Upper Seagry – Commercial

FRA Addendum 3 version 2 (February 2026)

A Flood Risk Assessment (FRA) including a drainage strategy was provided in July 2025 with the planning application for the proposed development of land at Seagry House located off Henn Lane and Startley Road, Upper Seagry, Chippenham, SN15 5HD. The planning application number is PL/2025/06615.

Figure 1 – Access and Egress Routes

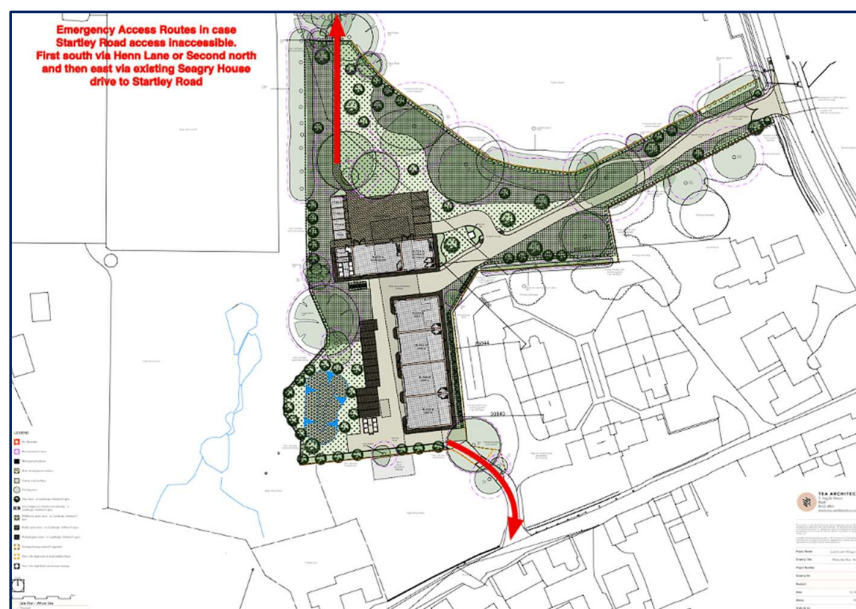
The LLFA have noted that the primary access and egress route to the site is predicted to be affected by surface water flooding, and that in line with the NPPF, an emergency plan would need to be agreed with WC.

We had previously requested that a plan for safe access / egress from the site during design flood conditions (as per PPG) would need to be provided. This will still need to be provided (we do note that the applicant states that alternative access can be achieved).

As noted in the November 2025 FRA Addendum, the site has two alternative access and egress routes which are unaffected by flood risk. There is a secondary access and egress route from the site to Henn Lane which is intended as an emergency access. There is also a tertiary access and egress route from the site along the existing track to the north along the front of Seagry House. These routes are illustrated in **Figure 1** included below.

As agreed with the LLFA, an emergency plan would be provided to ensure that the primary access and egress route would not be used during periods when it is flood affected, with the secondary or tertiary access and egress routes being alternatively used during these periods.

The FRA Addendum described and provided a figure showing the alternative access and egress routes, as shown in **Figure 1**.

As agreed with the LLFA, an emergency plan would be provided to ensure that the primary access and egress route would not be used during periods when it is flood affected, with the secondary or tertiary access and egress routes being alternatively used during these periods.

Drainage Strategy Plans (PDL-01)

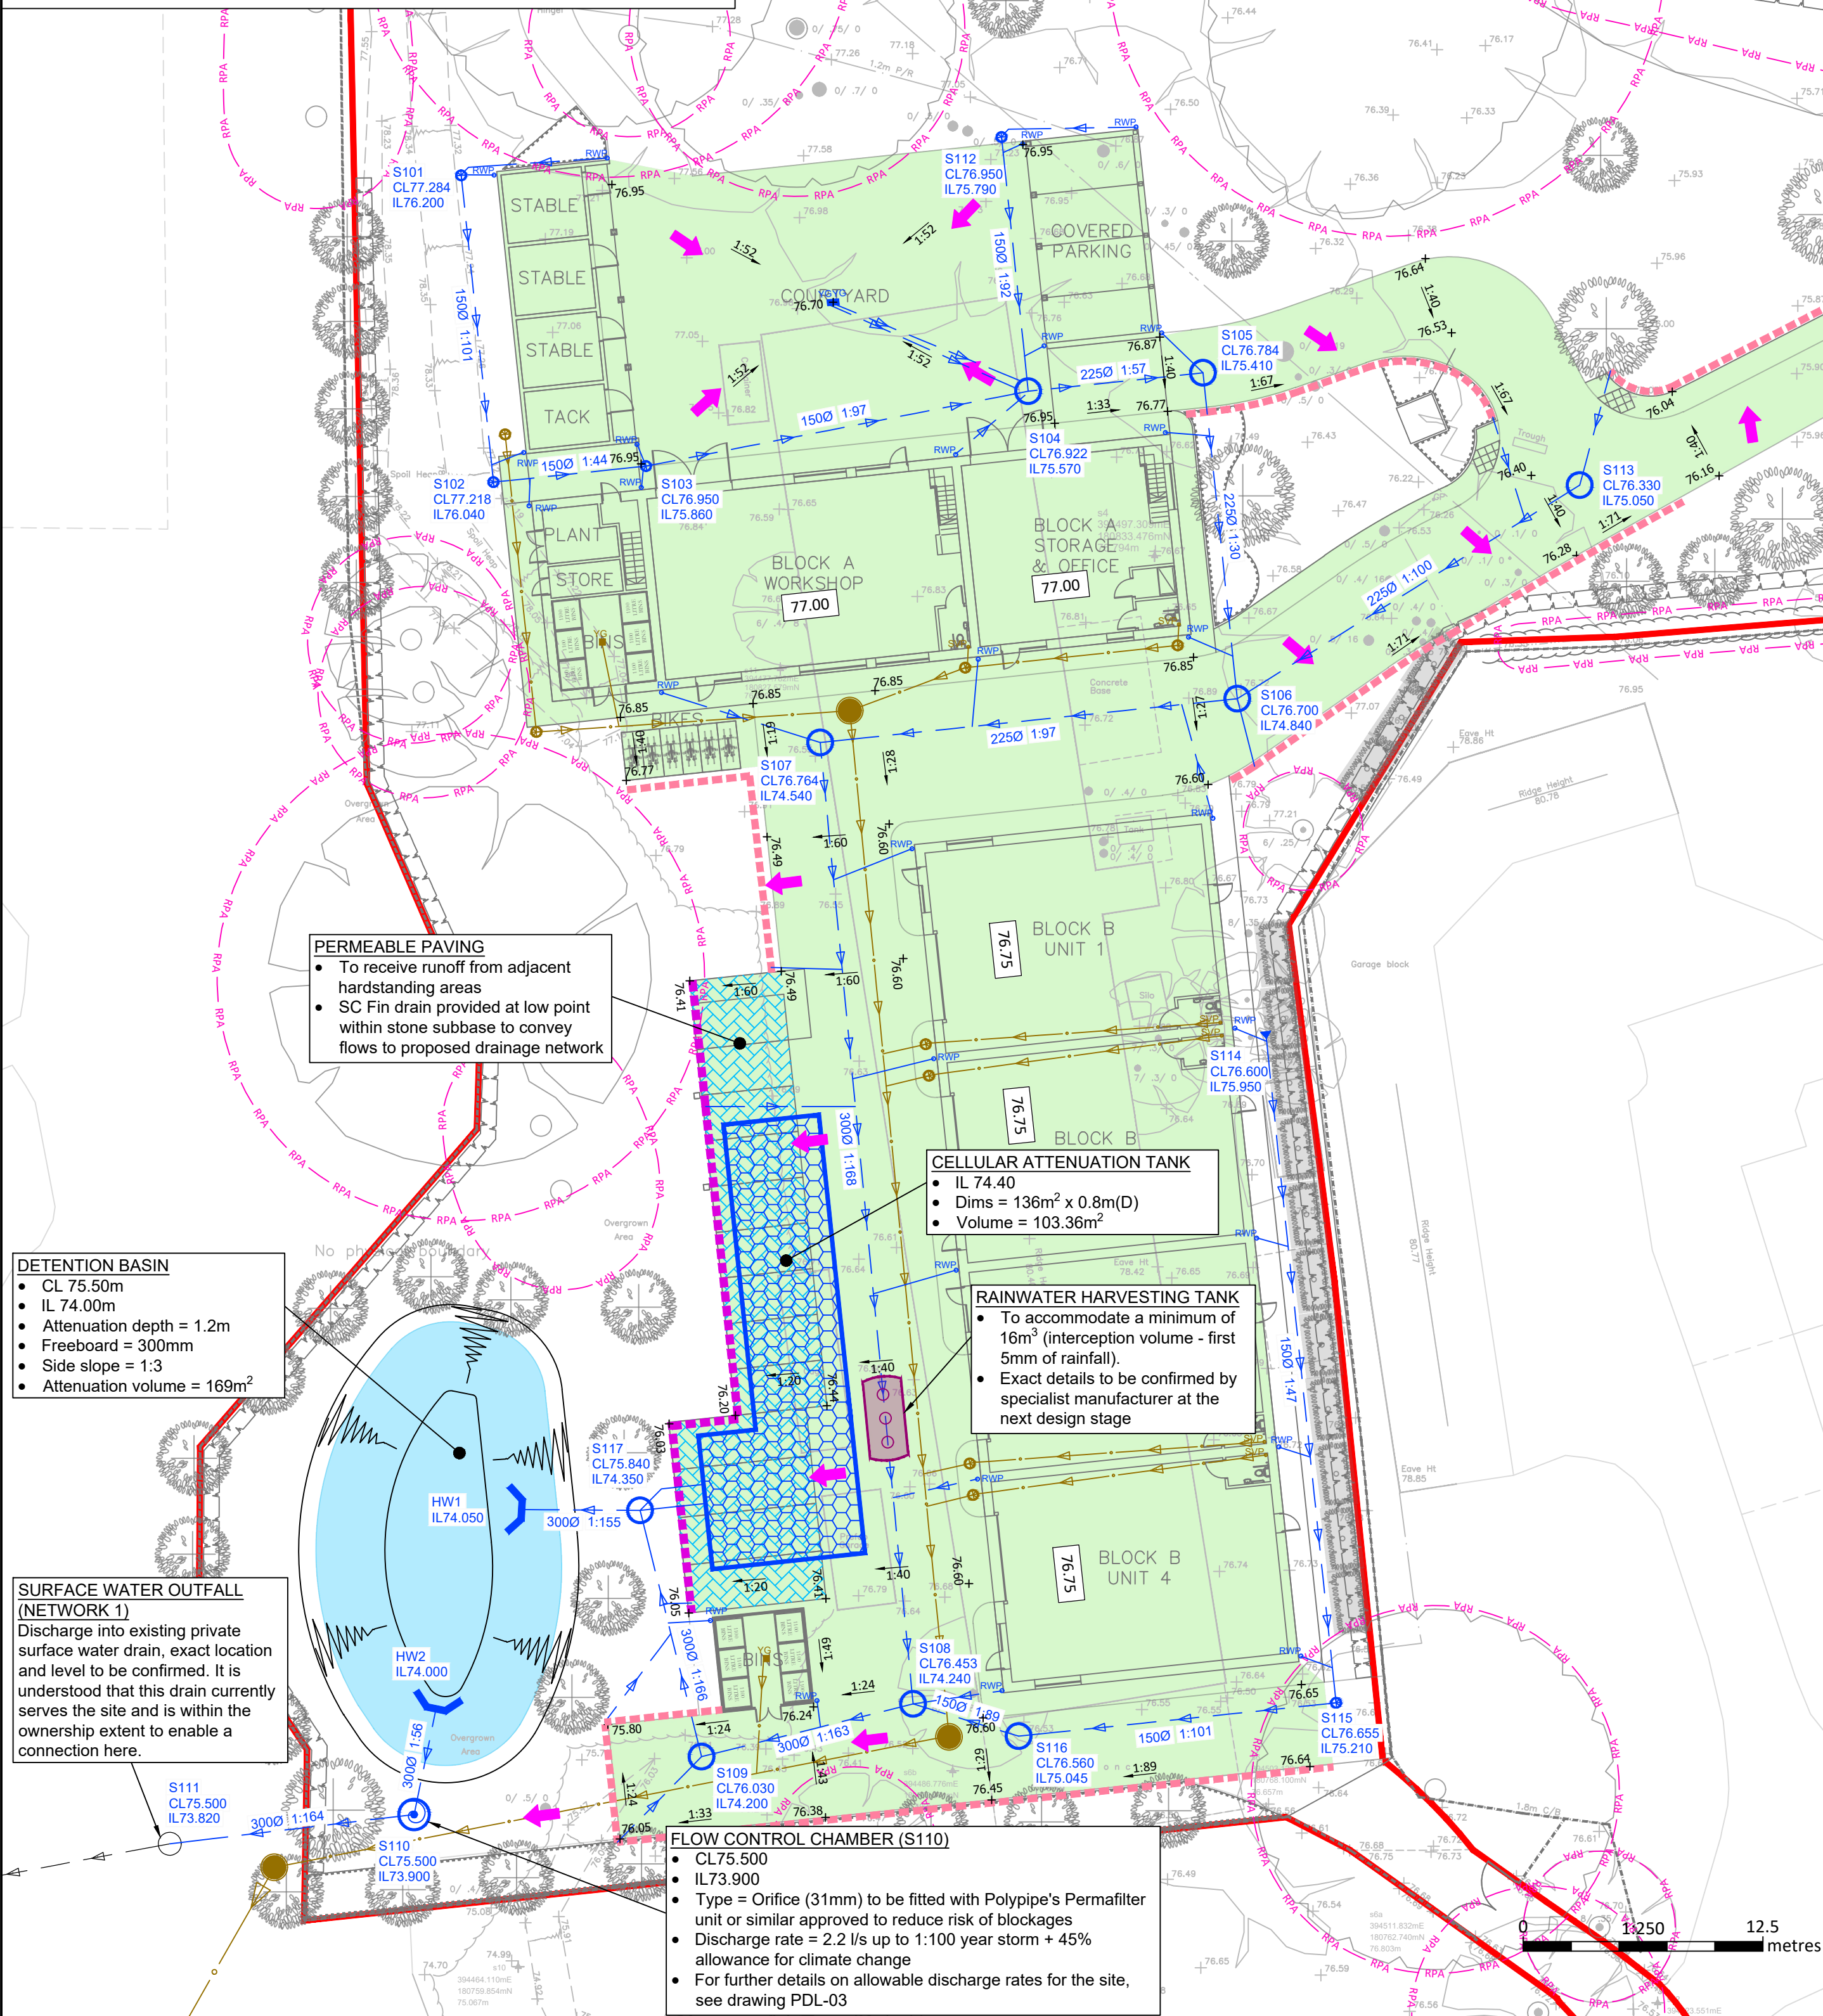
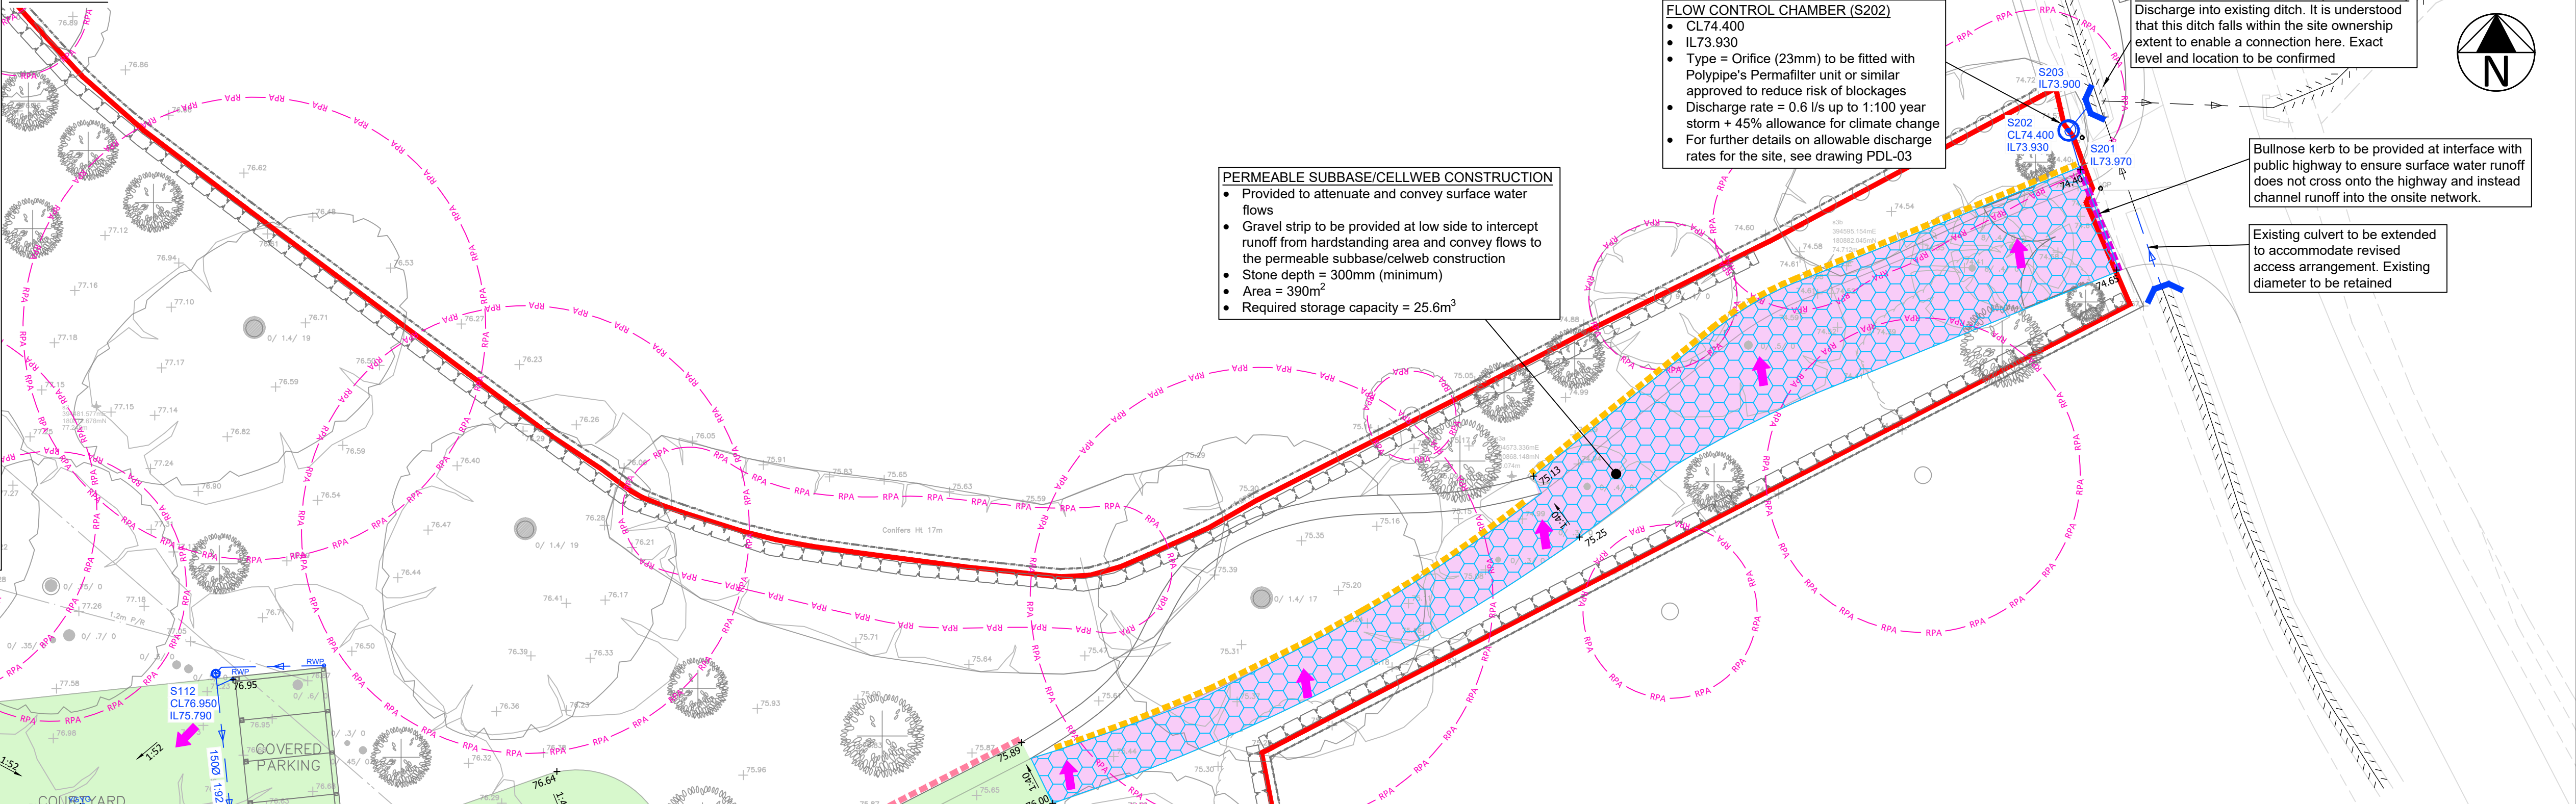
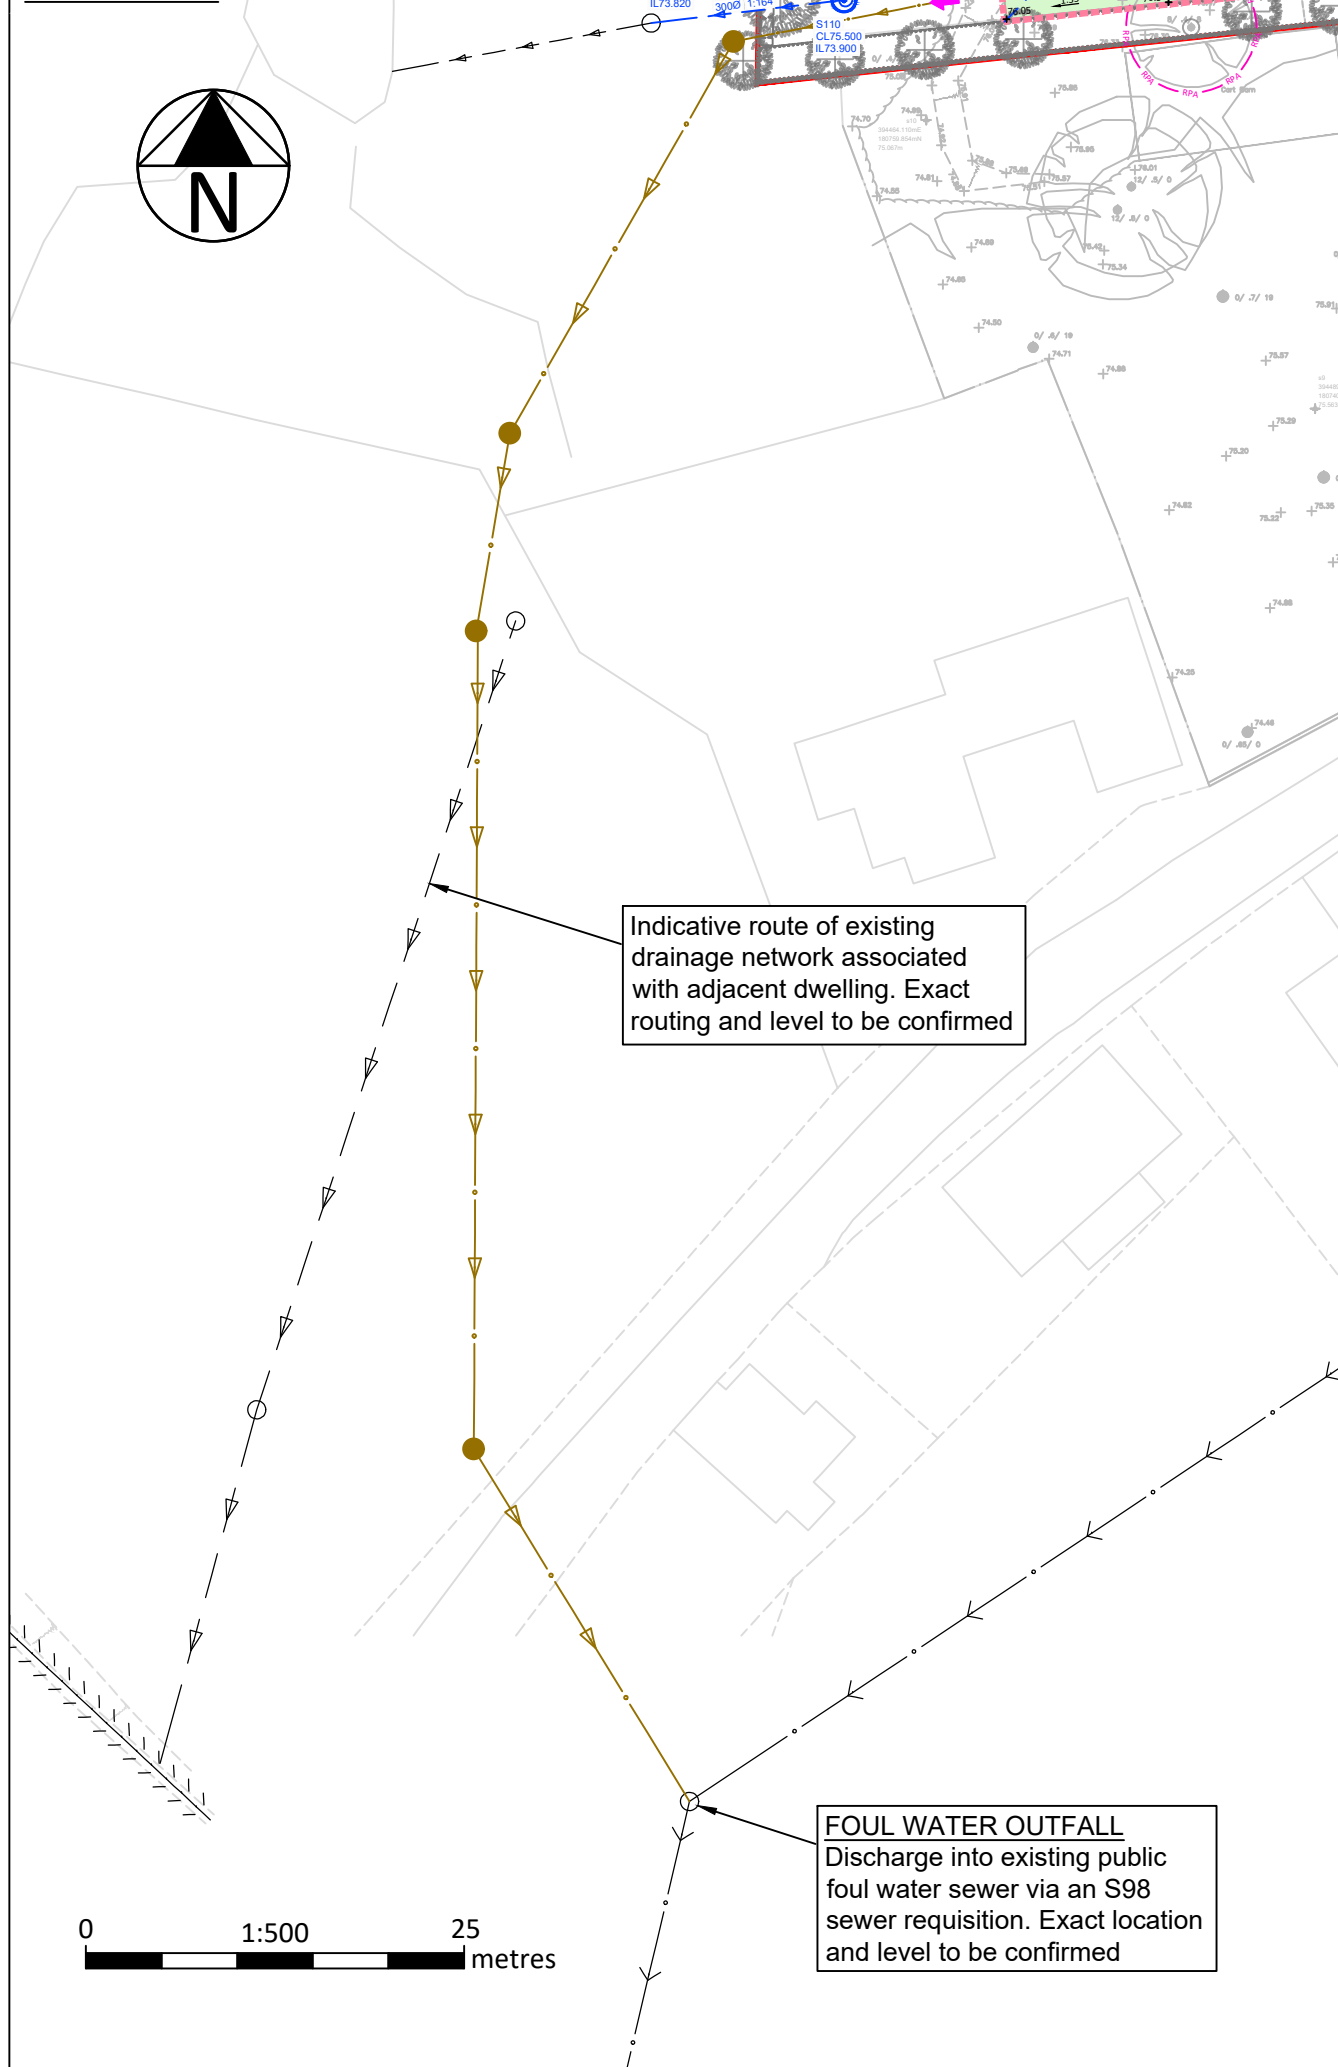
- *The submitted exceedance flow routing does not match the levels shown on the topographic survey in all locations. The applicant should confirm whether any re-levelling is planned to facilitate exceedance routing and submit any supporting topographical map for the proposed ground levels where required.*
- *The access to the site is predicted to flood, therefore in line with the National Planning Policy Framework, an emergency plan needs to be agreed with Wiltshire Council.*
- *With regards the control of surface water discharges from brownfield sites, Wiltshire Council requires post development discharges to be as close as reasonably practicable to greenfield runoff for both peak flow and volume.*

- i. *The western catchment includes an offline detention basin applied to node 110. This is currently modelled as online storage rather than the offline storage shown within the layout. The detention basin will need to be modelled as offline within the Causeway Flow model.*

With regards the eastern catchment we note that there are currently no formal features to prevent exceedance flows discharging to the highway – the applicant should provide additional definition as to how exceedance onto the highway will be prevented. We also note that the current system relies on a permeable subbase being overlayed with an impermeable bituminous surface, which is reliant on the performance of a gravel filter drain at the edge. We do not believe this design will be effective in distributing flows through the subbase as expected and would expect the applicant instead to adopt a permeable paving system including a permeable surface to promote better management of runoff.

The applicant needs to confirm whether any ground re-levelling is required to enable the proposed exceedance flow routing, as the drainage plan only shows arrows denoting exceedance flow route without any proposed grading details.

The post-development overland flow routes are included in **Appendix B** on **Figure PDL-01**. This demonstrates that these flow routes all drain to areas where they would be intercepted and therefore managed by features proposed as part of the drainage strategy.

In response to the comment from the LLFA, this drainage strategy plan now shows the proposed ground levels and the post-development overland flow routes. This therefore addresses the comment on whether this matches the topographic survey and whether any re-levelling is planned to facilitate exceedance routing.

As shown in **Appendix B**, the offline basin has been changed in the drainage design to an online basin.

As noted above and shown in **Appendix B**, the offline basin has been changed in the drainage design to an online basin and which therefore addresses this point.

We agreed with the LLFA to add a bullnose kerb between the site boundary and the delineated extent of public highways to convey exceedance water from the site to the adjacent gravel filter drain. This has now been included in the drainage design included as **Appendix B**.

REV.	DESCRIPTION	Date	BY	CHK
F	Drainage routing amended to provide an online detention basin. Note added at access requiring bullnose kerb	19/02/26	JH	AC
E	Proposed levels added and drainage updated to suit	14/01/26	JH	AC
D	Drainage updated to suit revised site layout and LLFA planning comments	14/10/25	JH	JH
C	Boundary removed	30/07/25	JH	AC
